Technical Bulletin SWEM20-001-TB

Subject:How to replace OLED in ICP panel

SWEM20-001-TB

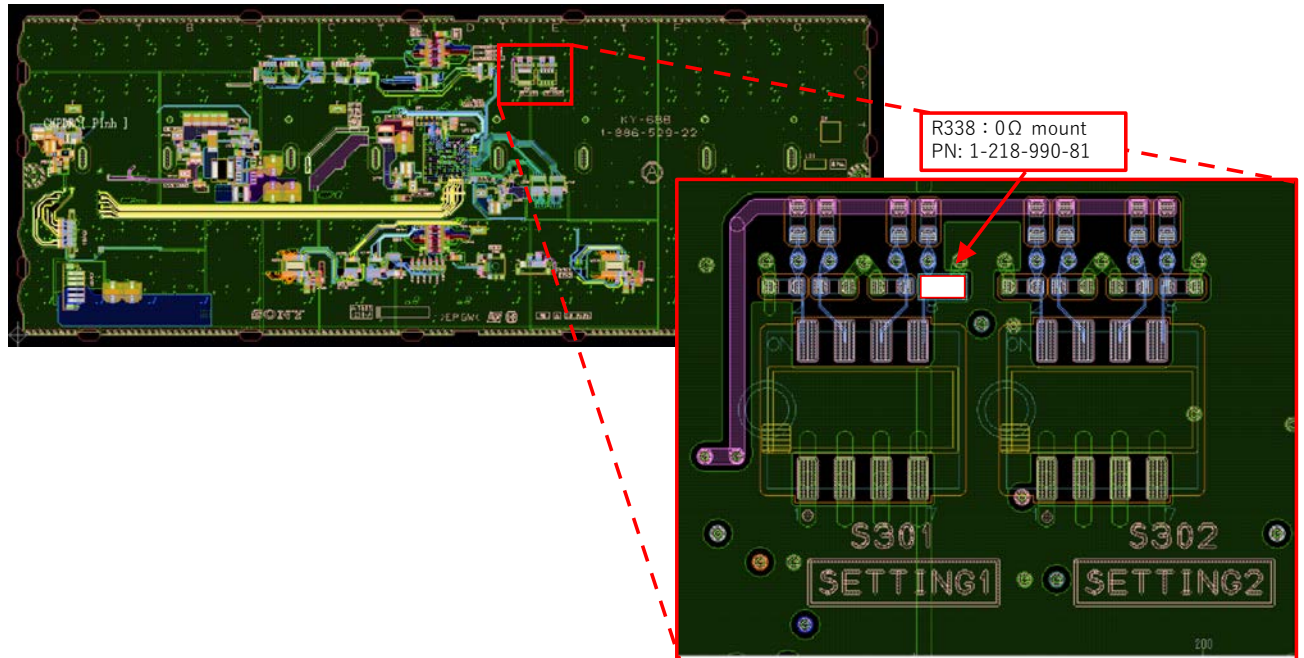
Refer to the service manual and remove all OLEDs and holders in the corresponding area.

KY-689 A Side

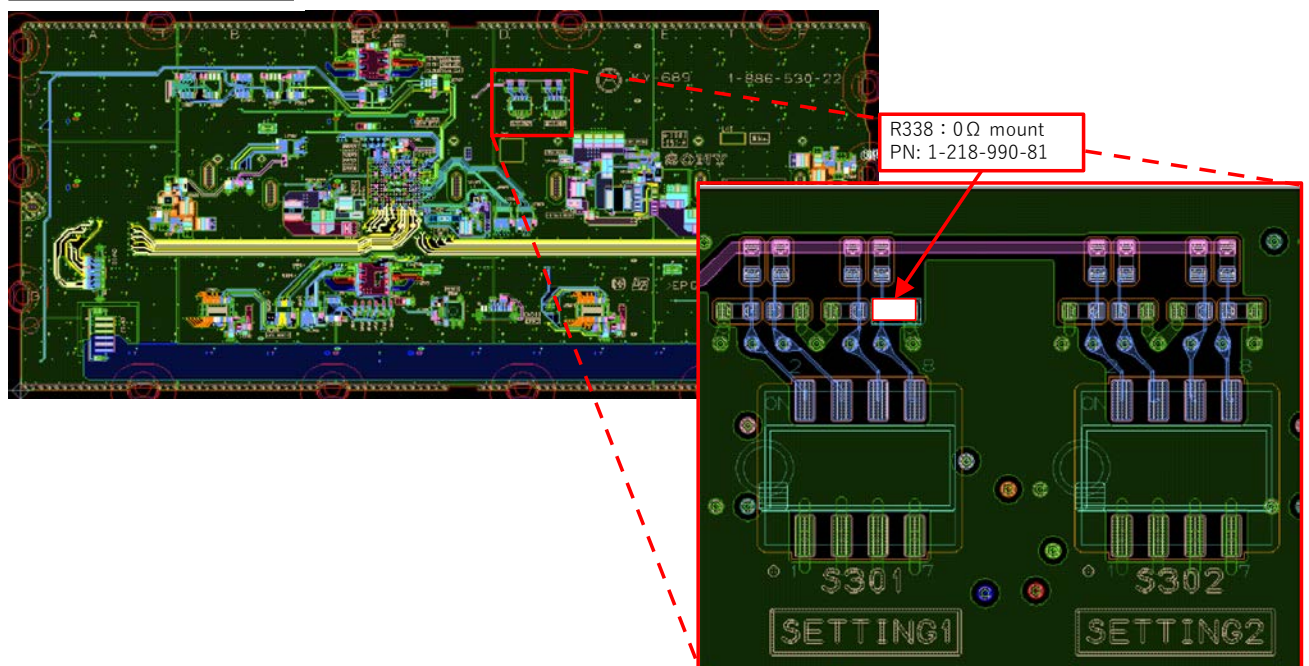
For areas B, E and H: KY-689

- Mount a 0Ω resistor on R338. (Set FPGA to new 2.7-inch OLED mode.)

KY-689 A Side

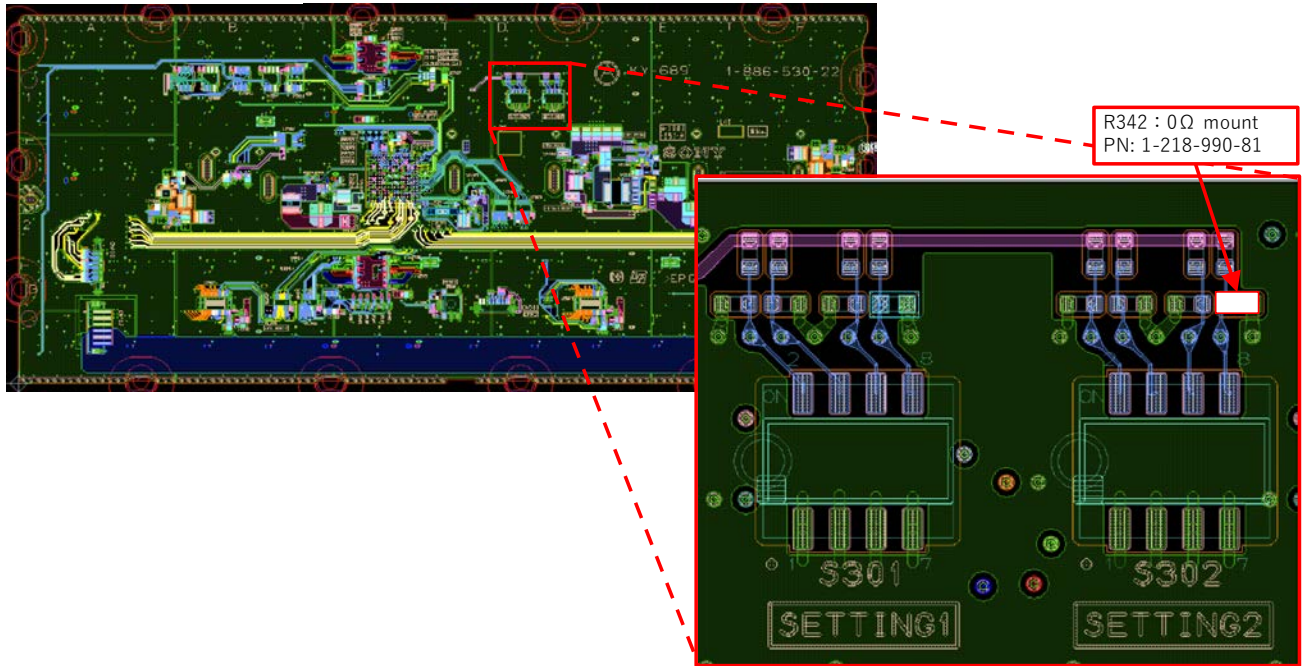
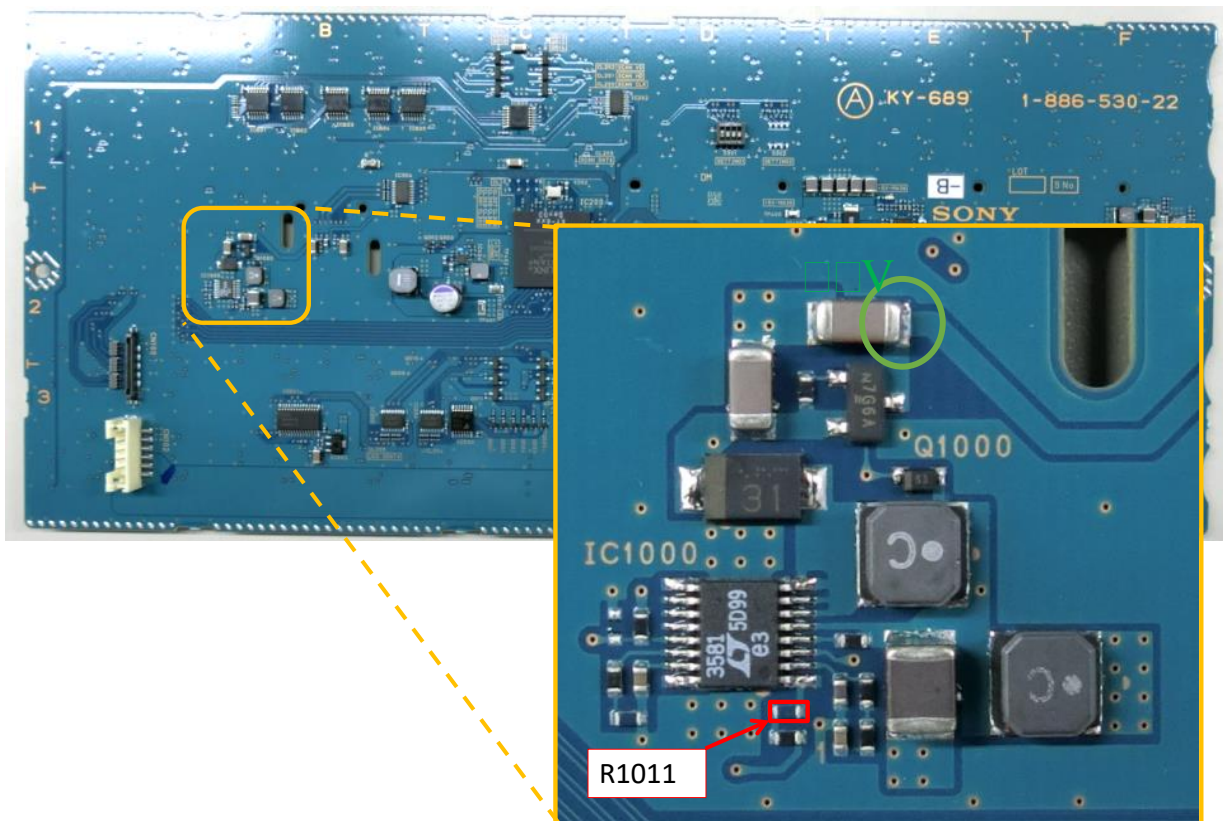
For areas C, F and J: KY-689

- Mount a 0Ω resistor on R342. (Set FPGA to new 0.8-inch OLED mode.)

- Remove R1011 and mount a $30\text{ k}\Omega$ resistor instead. ($10.4\text{V} \Rightarrow 12.0\text{V}$)

*If the repair is done correctly, the green part shows a voltage of 12V.

KY-699 A Side

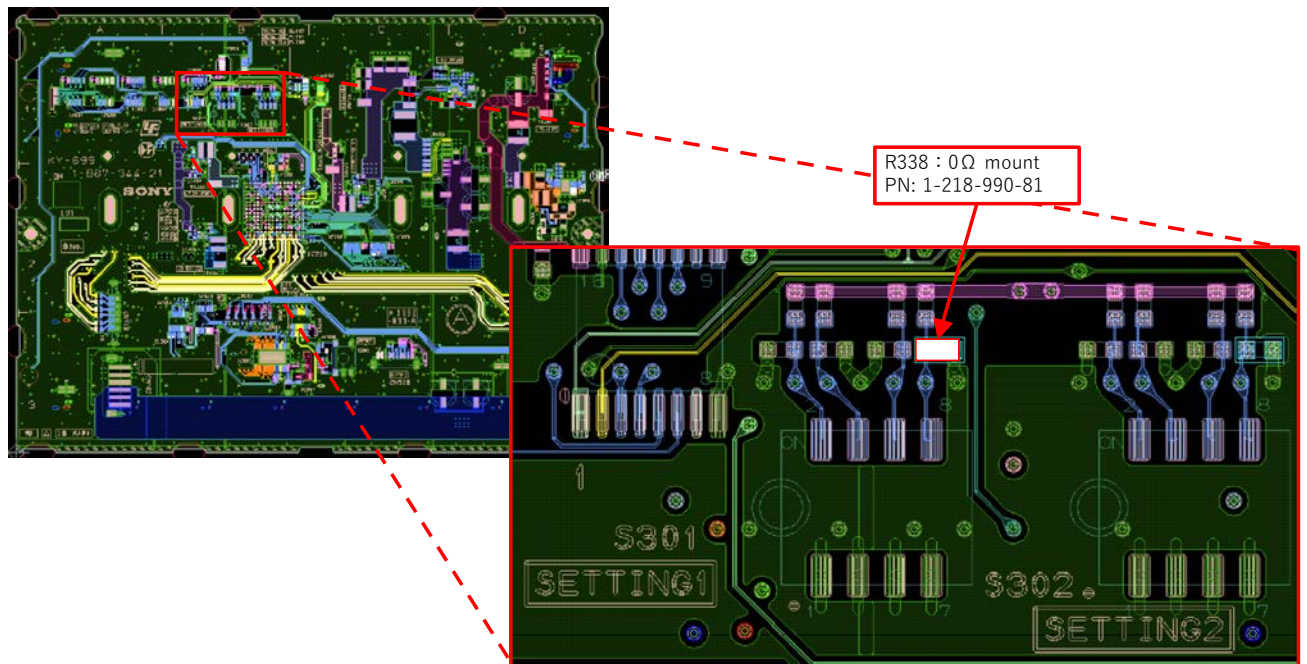
For areas K and L: KY-699

- Mount a 0 Ω resistor on R338. (Set FPGA to new 2.7-inch OLED mode.)

KY-690 A Side

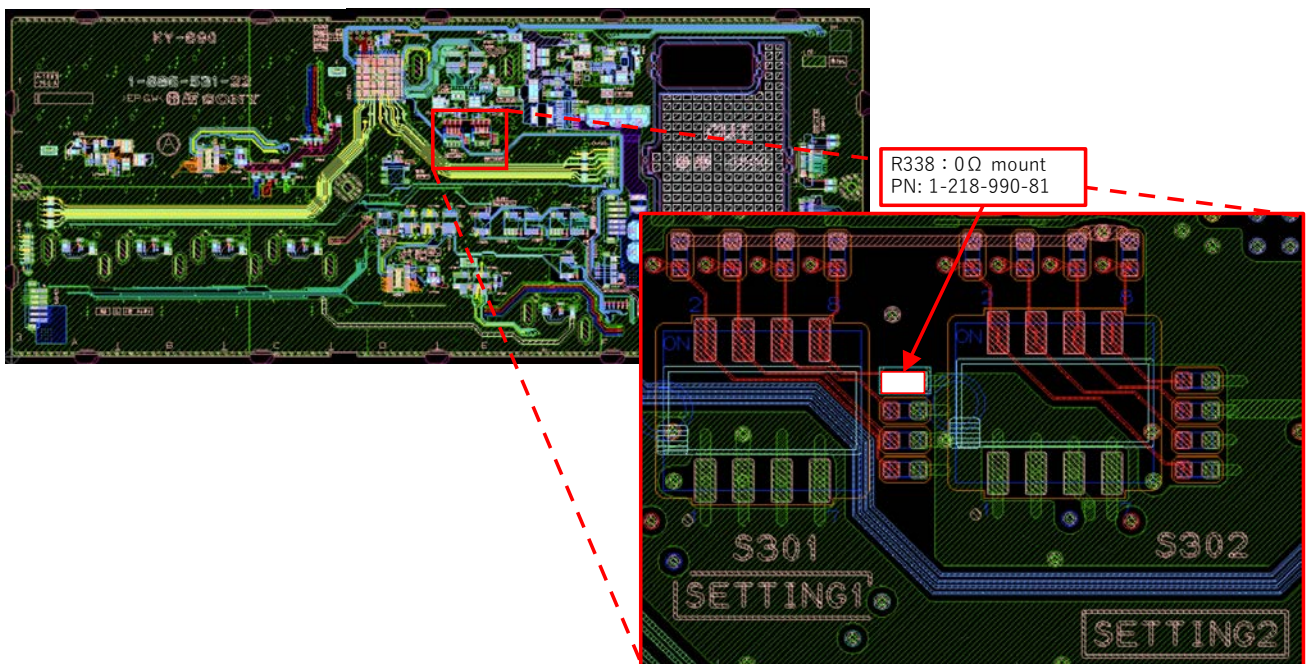
For area M: KY-690

- Mount a 0 Ω resistor on R338. (Set FPGA to new 2.7-inch OLED mode.)

KY-690 A Side

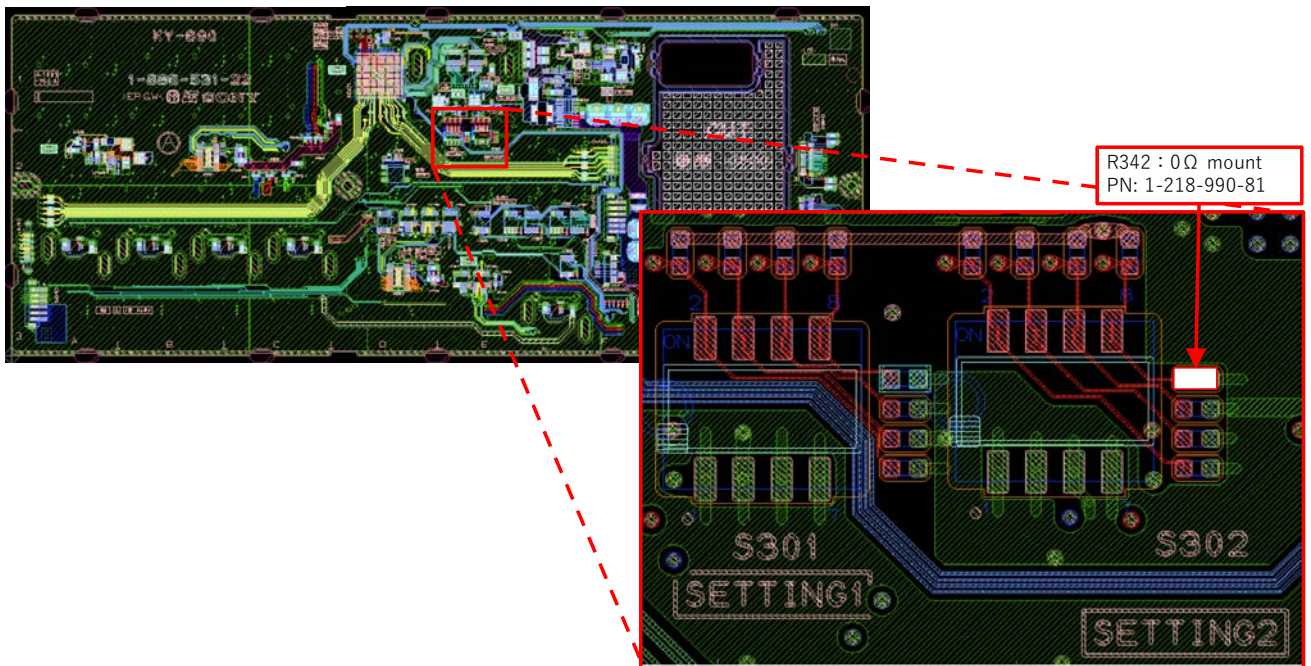
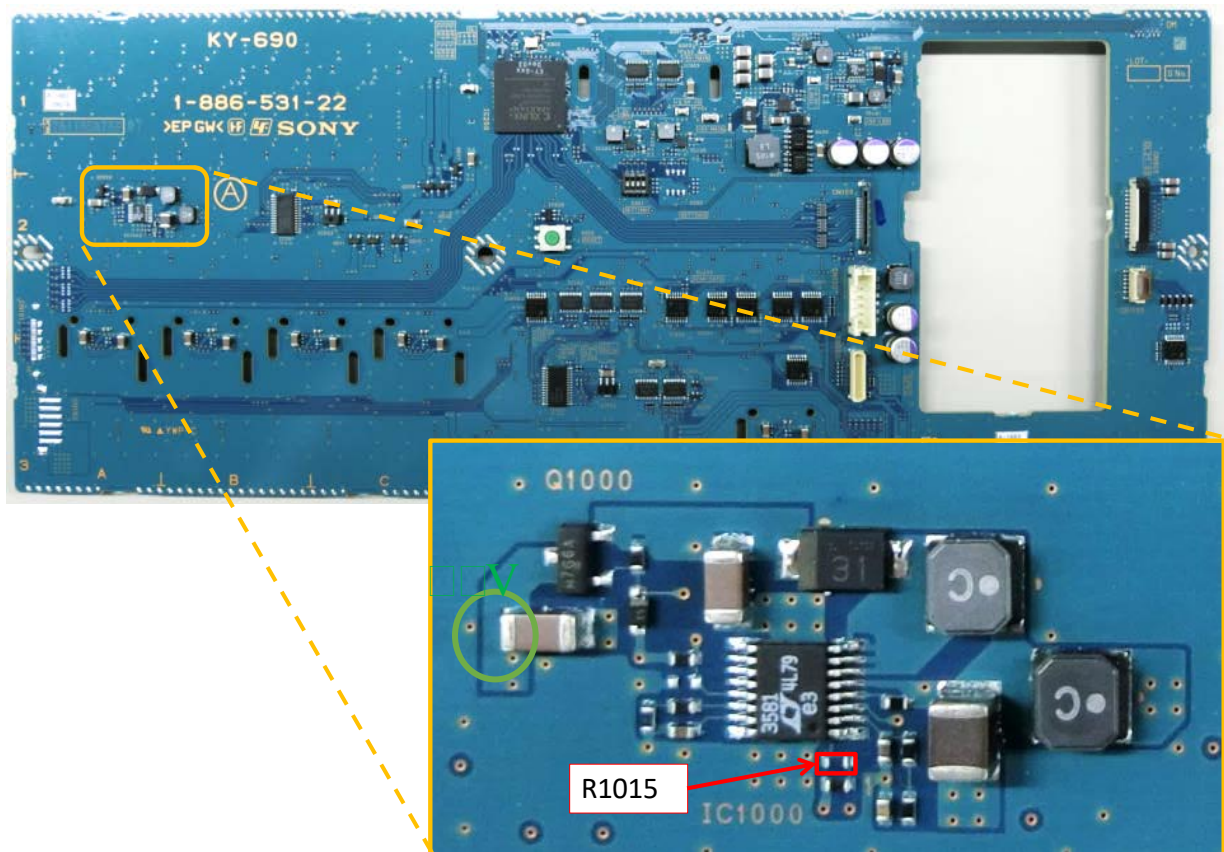
For area N: KY-690

- Mount a 0Ω resistor on R342. (Set FPGA to new 0.8-inch OLED.)

- Remove R1015; mount a 30kΩ resistor instead. (10.4V⇒12.0V)

*If the repair is done correctly, the green part shows a voltage of 12V.

KY-691 B Side

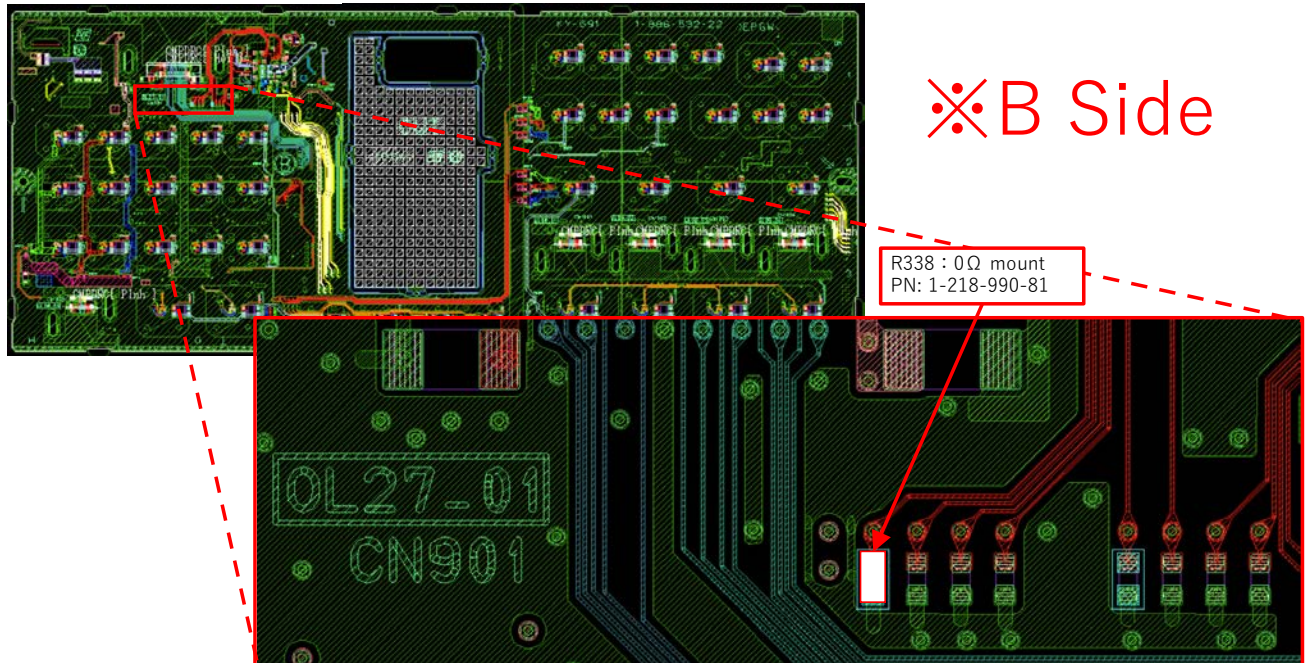
For area P: KY-691

- Mount a 0Ω resistor on R338. (Set FPGA to new 2.7-inch OLED mode.)

KY-691 B Side

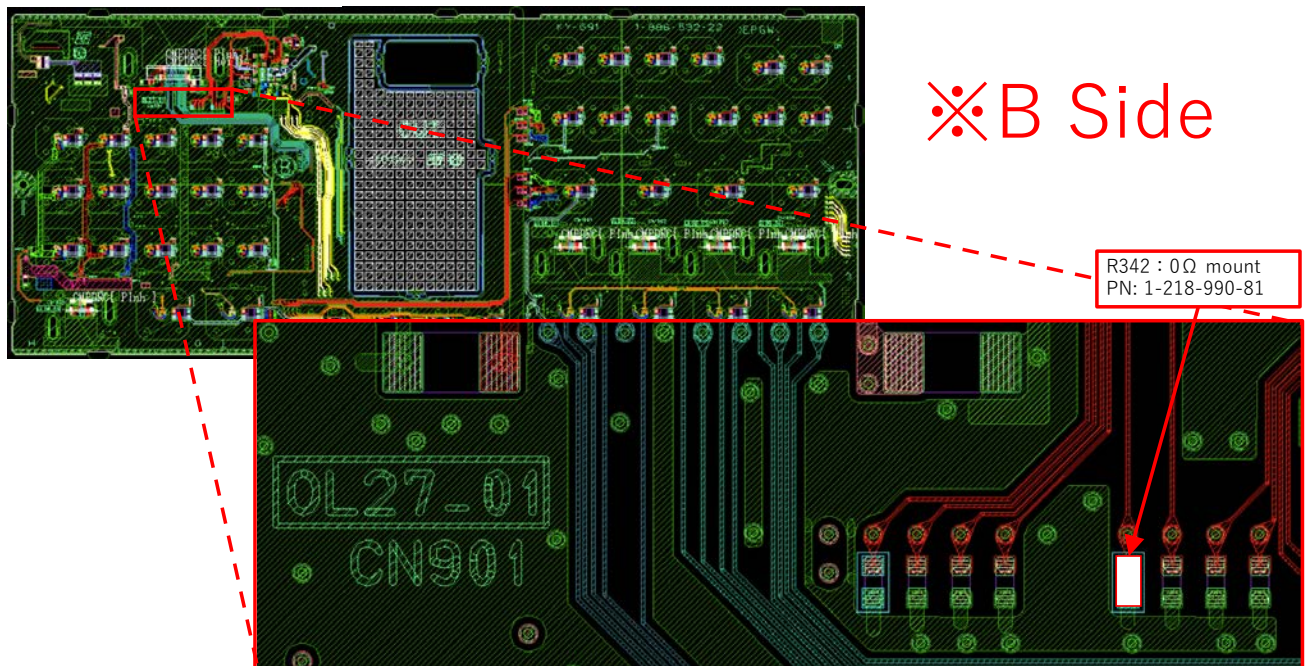
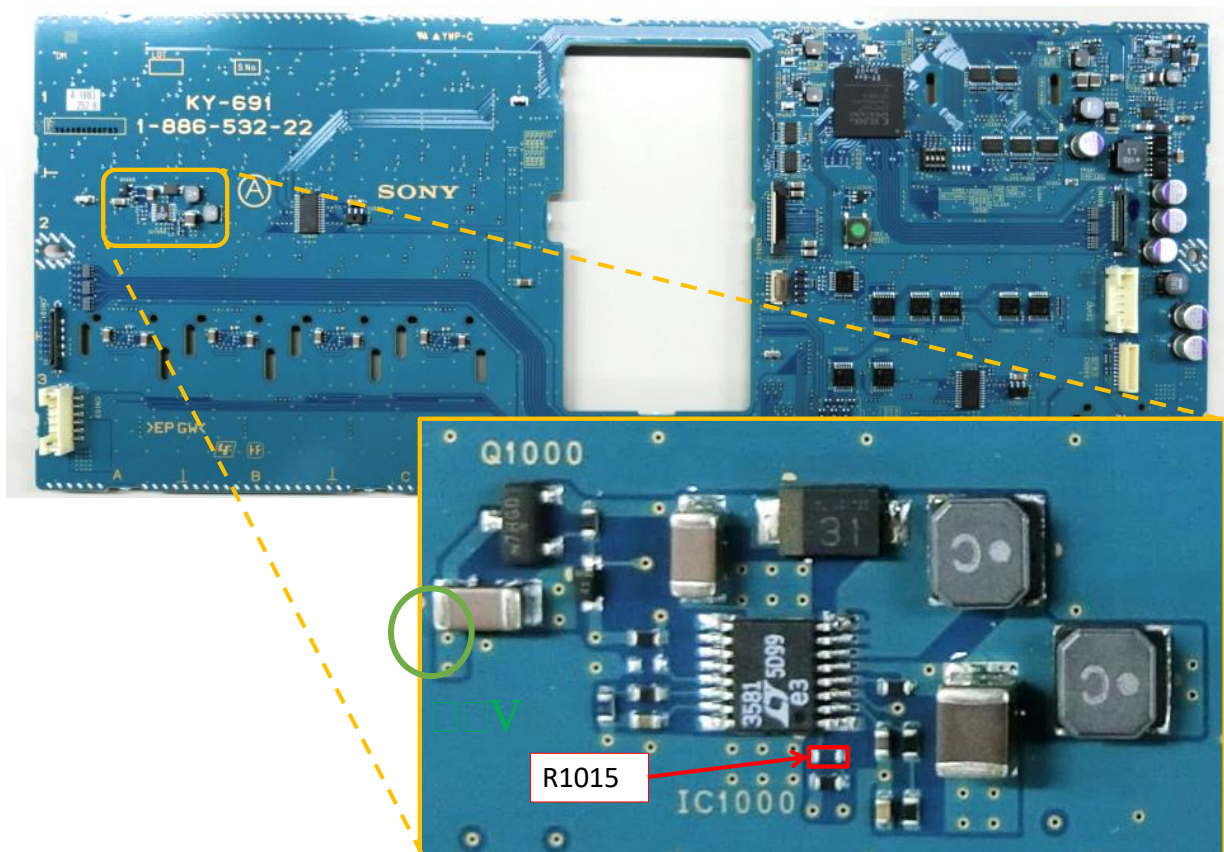
For area Q: KY-691

- Mount a 0Ω resistor on R342. (Set FPGA to new 0.8-inch OLED mode.)

- Remove R1015 and mount a 30kΩ resistor instead. (10.4V⇒12.0V)

*If the repair is done correctly, the green part shows the voltage of 12V.

KY-692 A Side

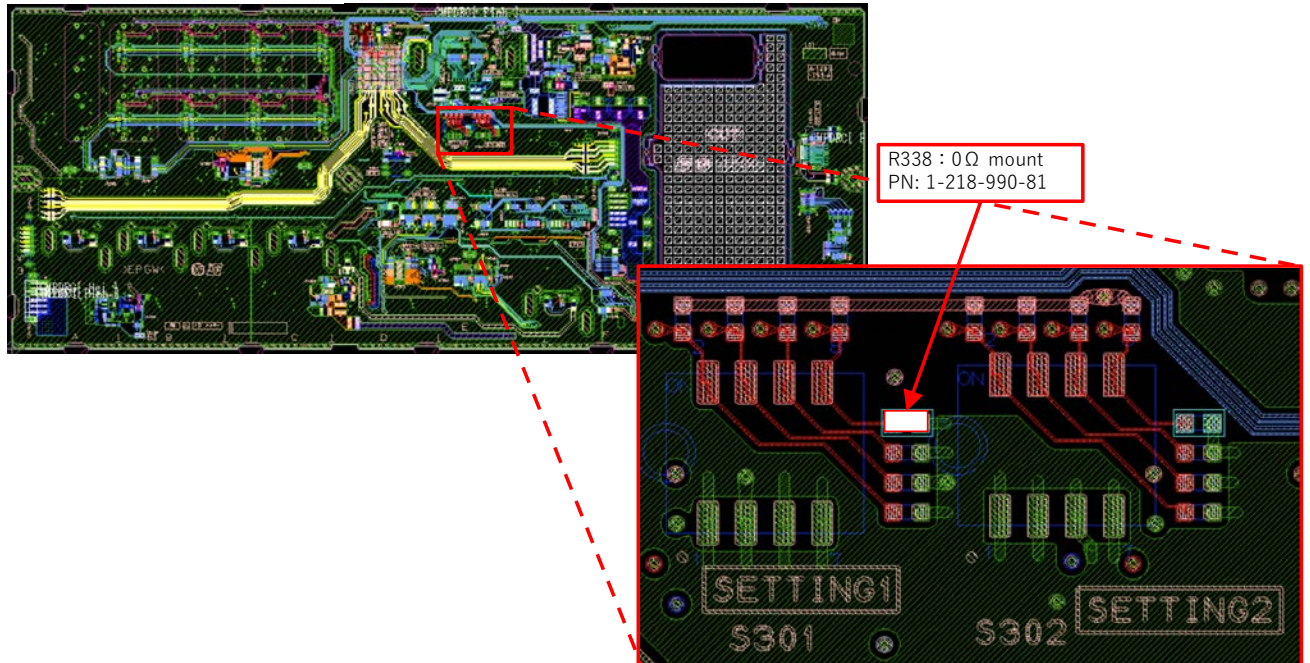
For area R: KY-692

- Mount a 0Ω resistor at R338. (Set FPGA to new 2.7-inch OLED mode.)
